**Vision Beyond Borders
Commercial Development Plan**

Planning Commission Meeting

Case Number: 24.04 DEV

Summary: The applicant is proposing to construct a commercial pole building.

C8.0

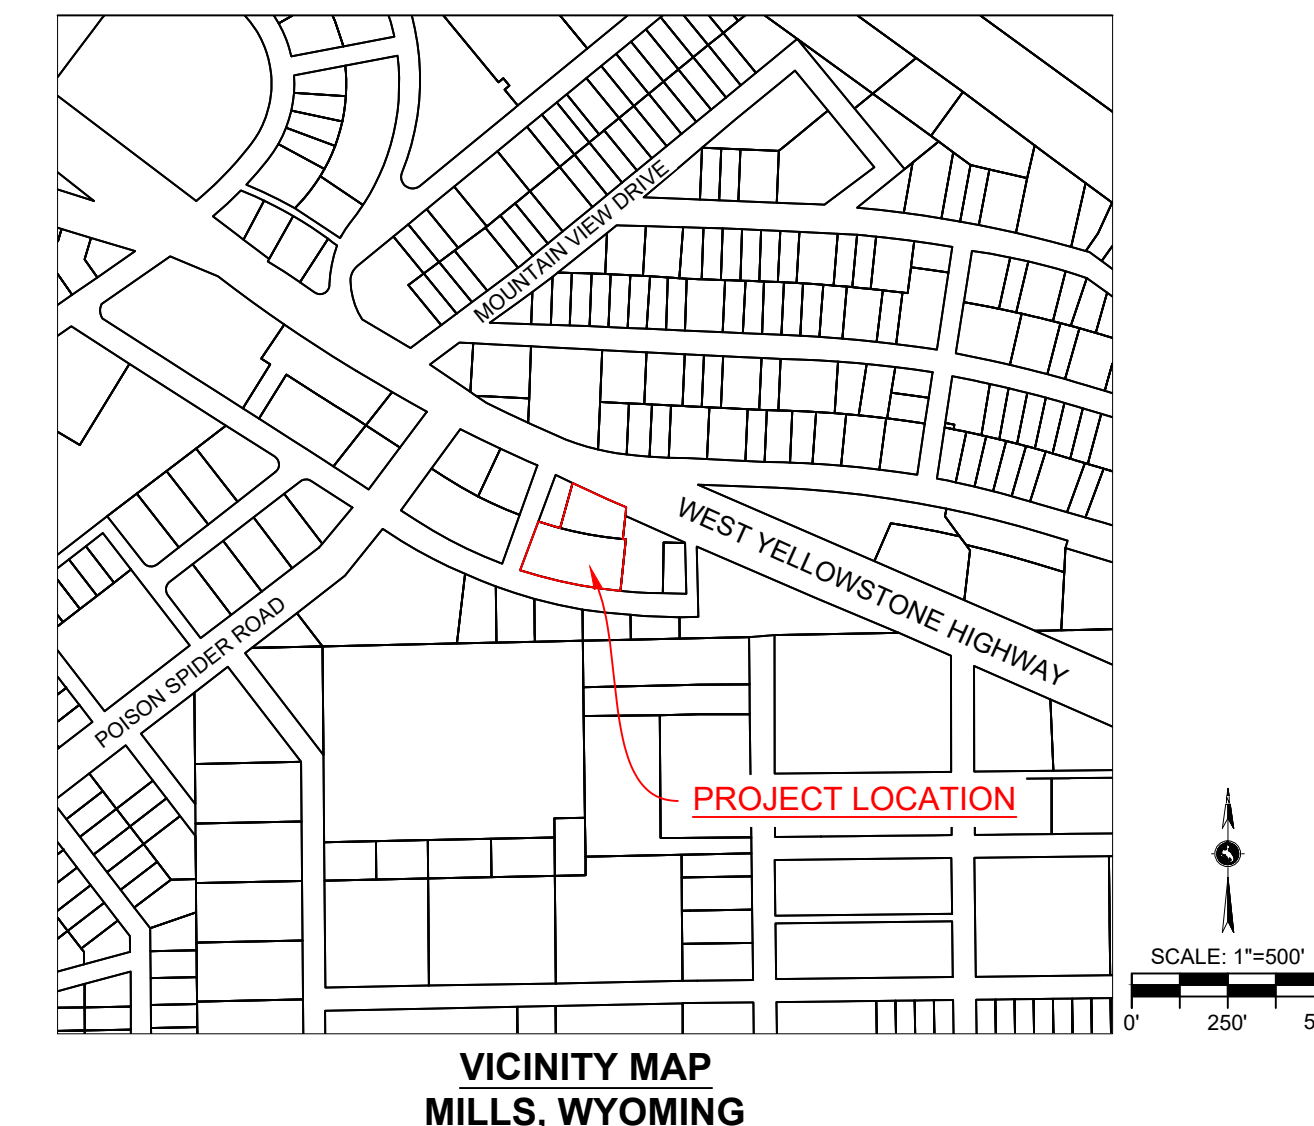
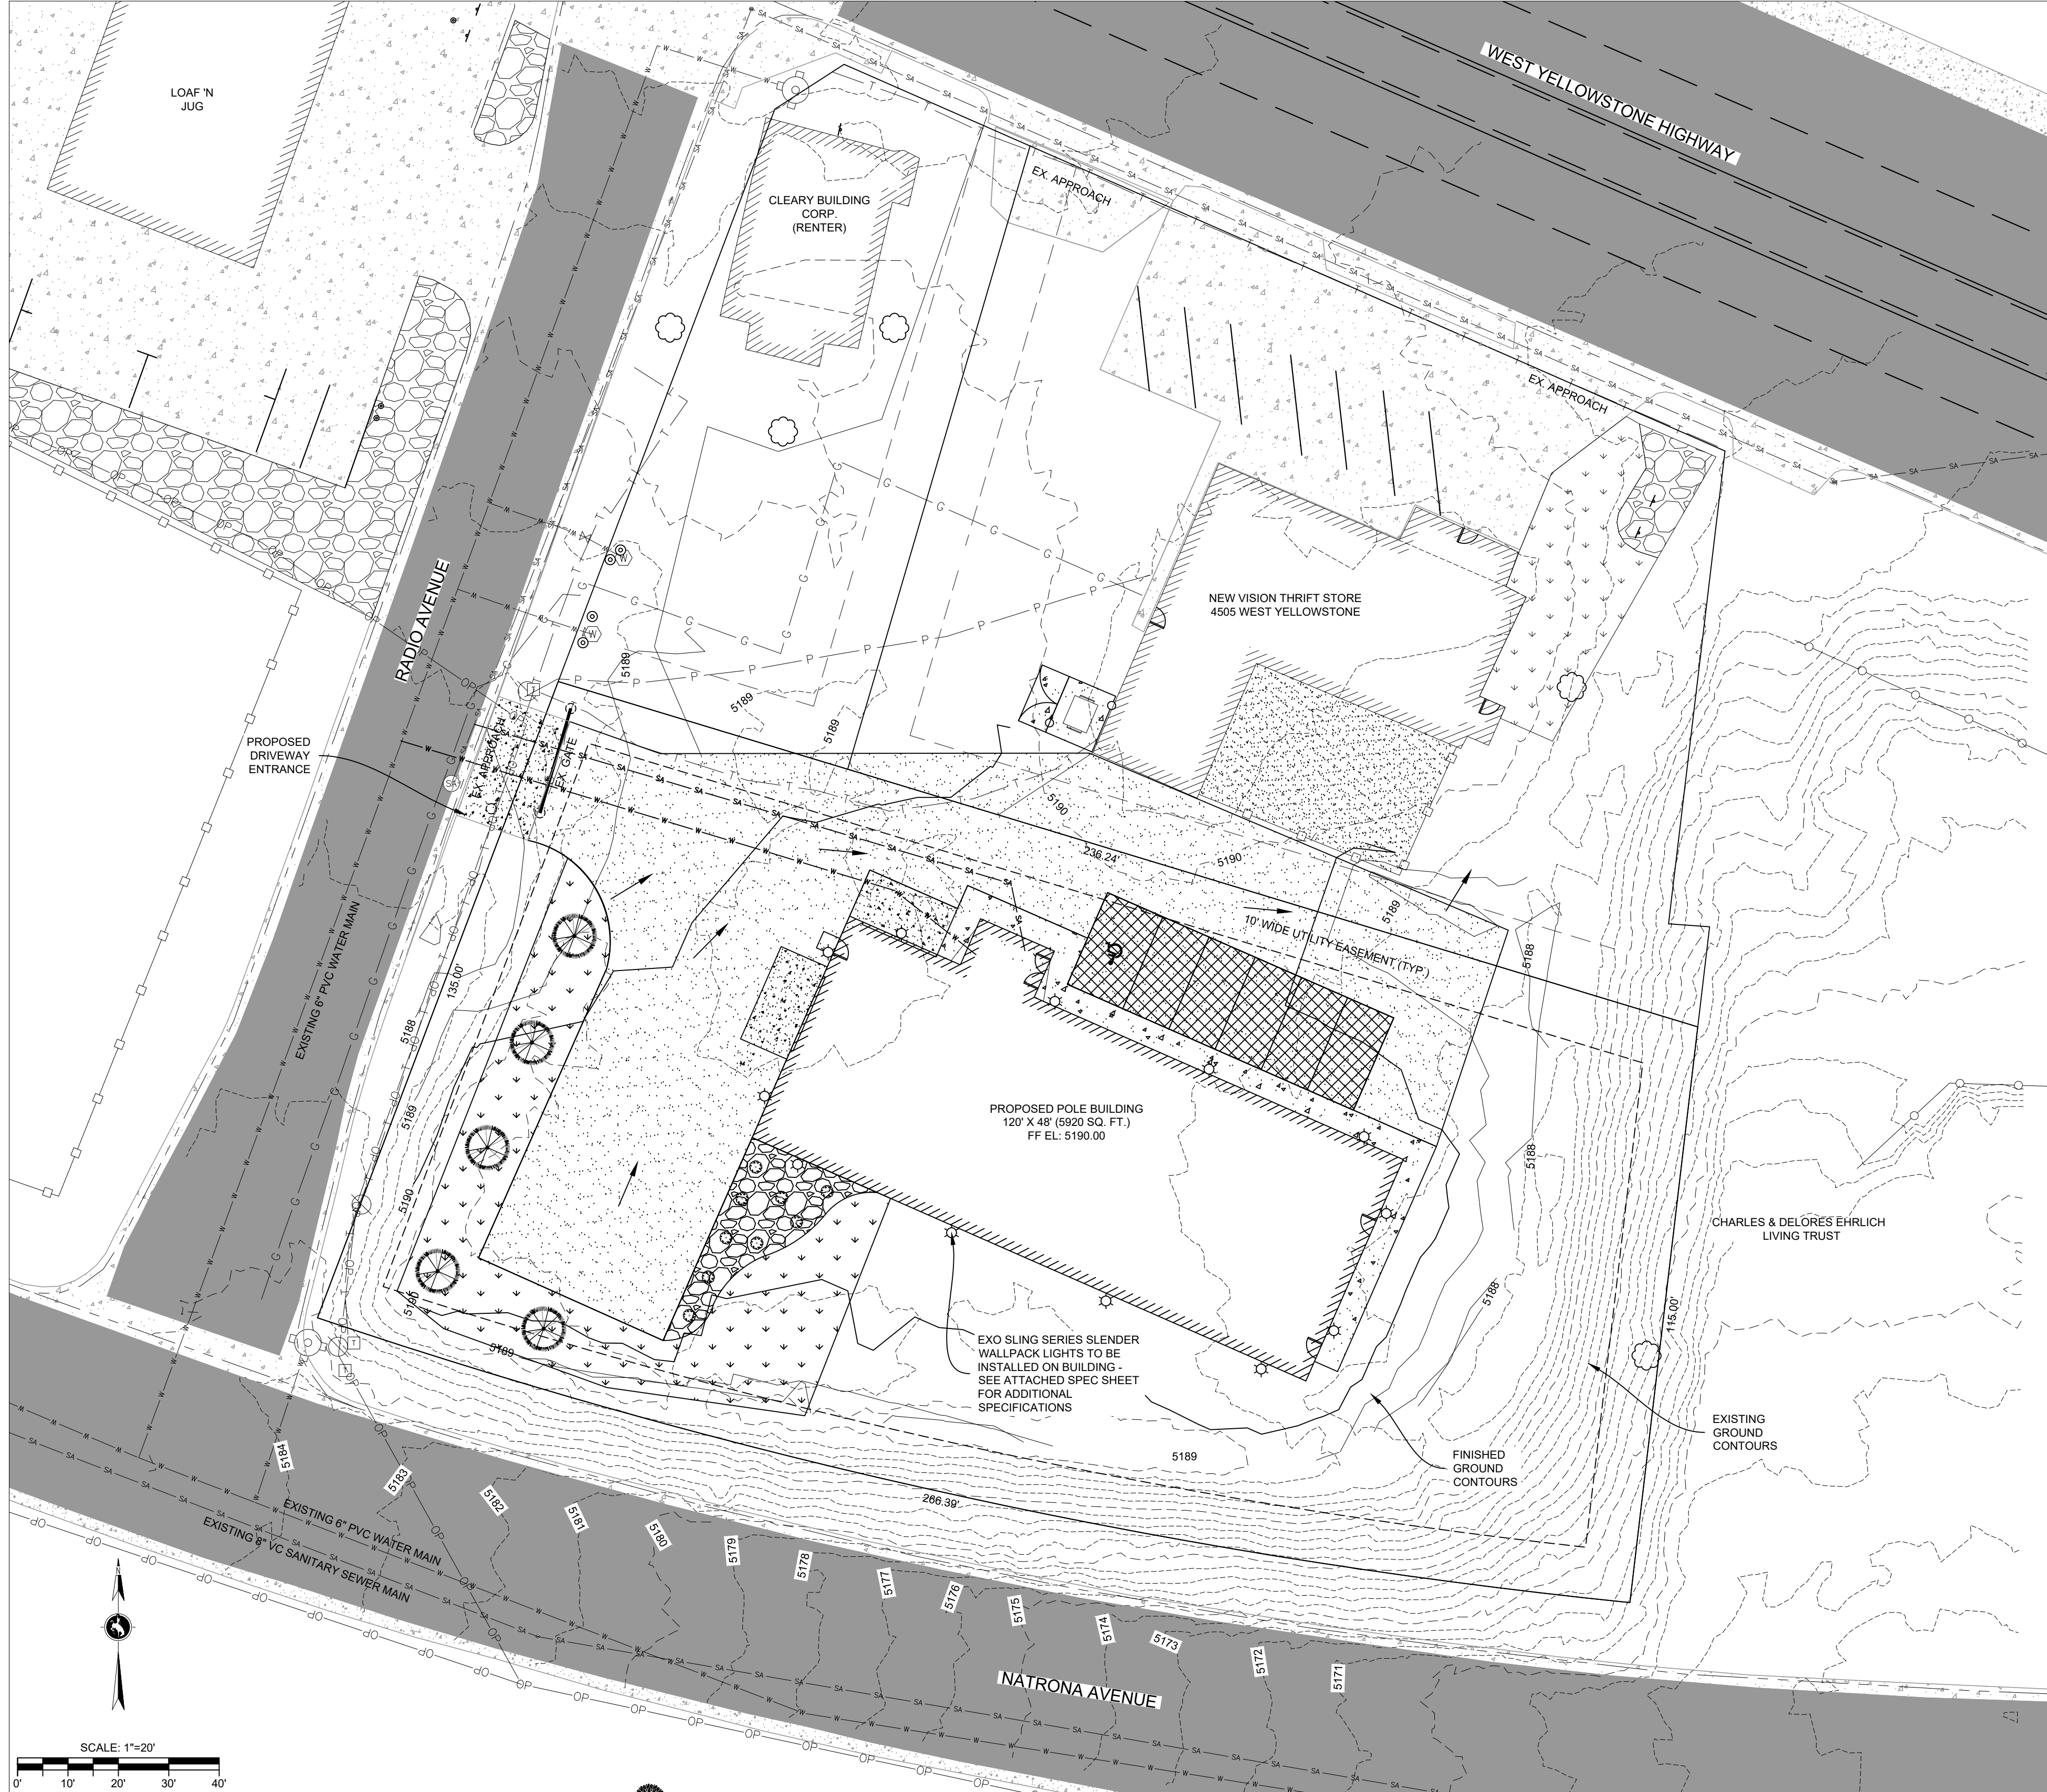
1. The previous application contained a conceptual exterior lighting plan. A more detailed exterior lighting plan has been provided with this submittal and appears to be in conformance with the LDRs.

- a. No parking lot lighting is proposed
 - b. Exterior lighting will be limited to the building with shielded wall-packs. The applicant needs to specify which model of the Sling Series Slender Wallpack light will be utilized.
